April 27, 1981

Subject: Dresden 2
SEP Topic III-6, Seismic Design Considerations
and III-11, Component Integrity
NRC Docket No. 50-237

Commonwealth Edison had EDS review the EGG-EA-5065 "Summary of the Dresden Unit 2 Piping Calculations" report transmitted by reference (a). The positive findings given in the report were based upon the original design information and the SSRT report on Dresden 2.

FIGURE 1 COMPARISON OF HORIZONTAL AND VERTICAL SPECTRA

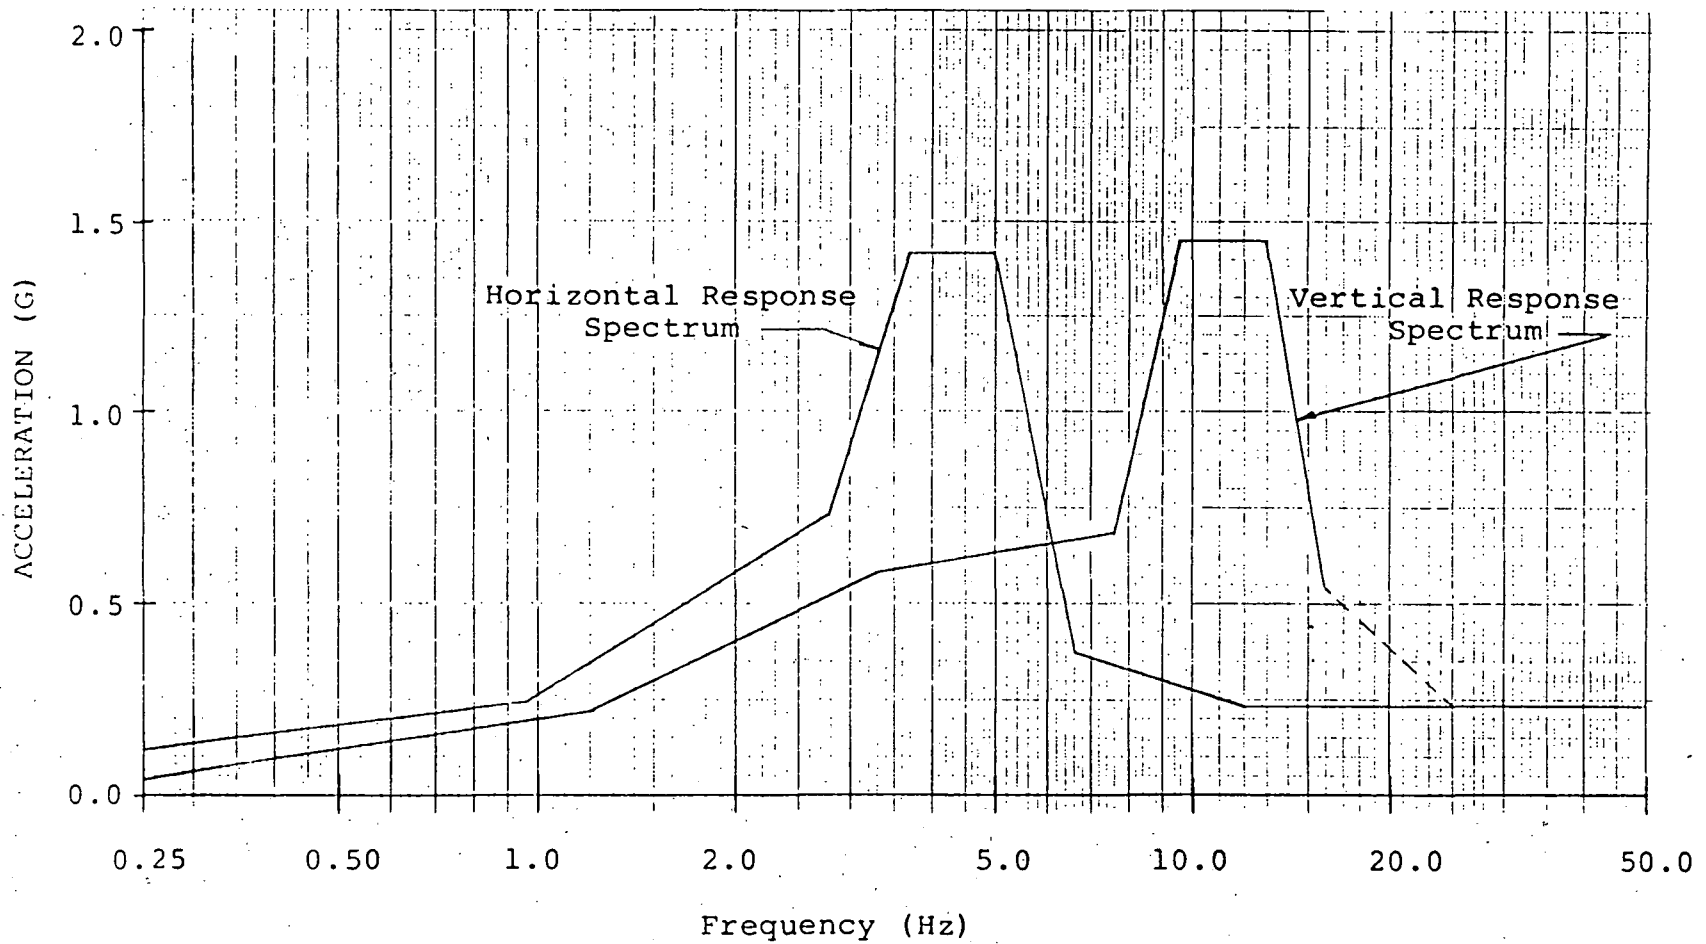
The OBE and SSE response spectra for the analyses in the EG & G Report were taken from the original John Blume Floor Spectra and the SSRT report for Dresden 2, respectively. The OBE spectrum was developed for the analysis of Reactor Building piping systems by John A. Blume & Associates, and the SSE spectrum was developed for the safety assessment of the Dresden Unit 2 piping system under the SEP Program. These spectra were reviewed for appropriate applications and we conclude that spectra applied were directly scaled from the horizontal spectra across the entire frequency range. Horizontal and vertical response spectra are compared in Figure 1 for a typical nuclear power plant. The frequency shift as shown in the figure is expected to similarly occur for the Dresden response spectra. The EG & G vertical spectra are, however, more appropriate than the flat vertical spectra used in the original design.

1. As-built pipe configuration - final as-built configurations following IE Bulletin 79-14 modifications would be used.
2. Pipe boundary conditions - adequate overlap techniques would be used when a physical anchor is not available for termination of the piping model.
3. Seismic model combinations - effect of closely spaced modes should be considered as per NRC Regulatory Guide 1.92.
4. Equipment stiffness - Realistic pump component stiffnesses would be used. This information is usually included in the pump stress report.
5. Vertical response spectra - Specific building vertical spectra would be used instead of the 2/3 scaling factor. In the absence of specific vertical spectra, we would use the 2/3 factor.

FIGURE 1 COMPARISON OF HORIZONTAL AND VERTICAL SPECTRA
 (Typical Reactor Building - GE Mark I, Similar to Dresden -
 SSE 3% Damping)

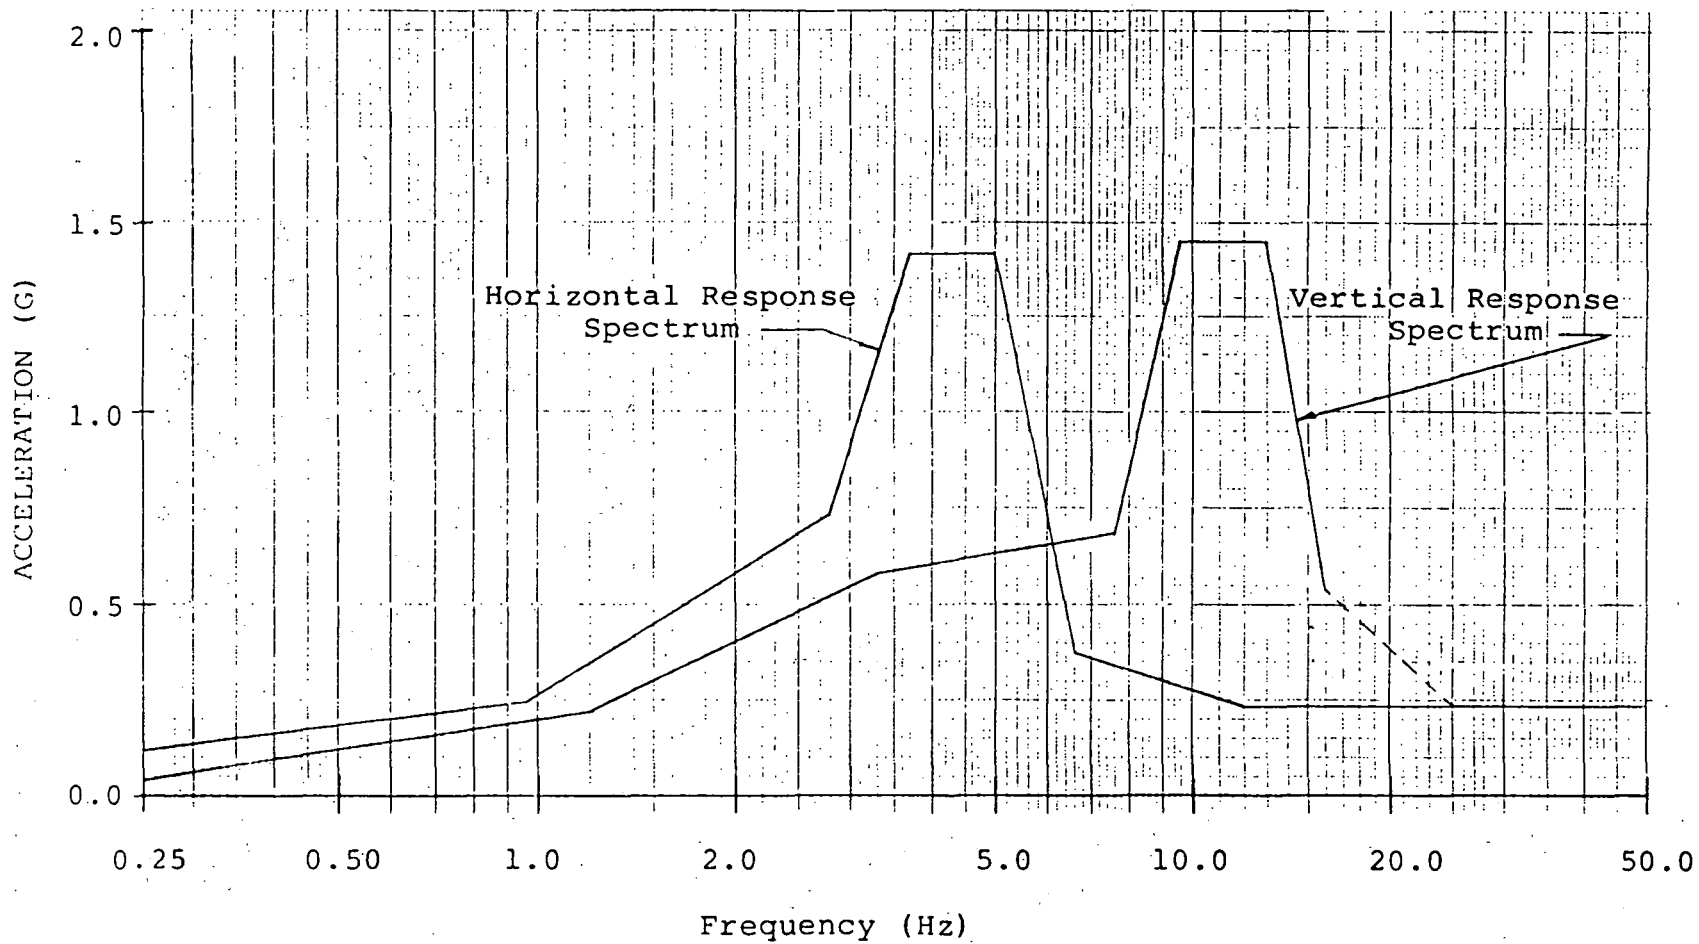
The OBE and SSE response spectra for the analyses in the EG & G Report were taken from the original John Blume Floor Spectra and the SSRT report for Dresden 2, respectively. The OBE spectrum was developed for the analysis of Reactor Building piping systems by John A. Blume & Associates, and the SSE spectrum was developed for the safety assessment of the Dresden Unit 2 piping system under the SEP Program. These spectra were reviewed for appropriate applications and we conclude that spectra applied were directly scaled from the horizontal spectra across the entire frequency range. Horizontal and vertical response spectra are compared in Figure 1 for a typical nuclear power plant. The frequency shift as shown in the figure is expected to similarly occur for the Dresden response spectra. The EG & G vertical spectra are, however, more appropriate than the flat vertical spectra used in the original design.

1. As-built pipe configuration - final as-built configurations following IE Bulletin 79-14 modifications would be used.
2. Pipe boundary conditions - adequate overlap techniques would be used when a physical anchor is not available for termination of the piping model.
3. Seismic model combinations - effect of closely spaced modes should be considered as per NRC Regulatory Guide 1.92.
4. Equipment stiffness - Realistic pump component stiffnesses would be used. This information is usually included in the pump stress report.
5. Vertical response spectra - Specific building vertical spectra would be used instead of the 2/3 scaling factor. In the absence of specific vertical spectra, we would use the 2/3 factor.
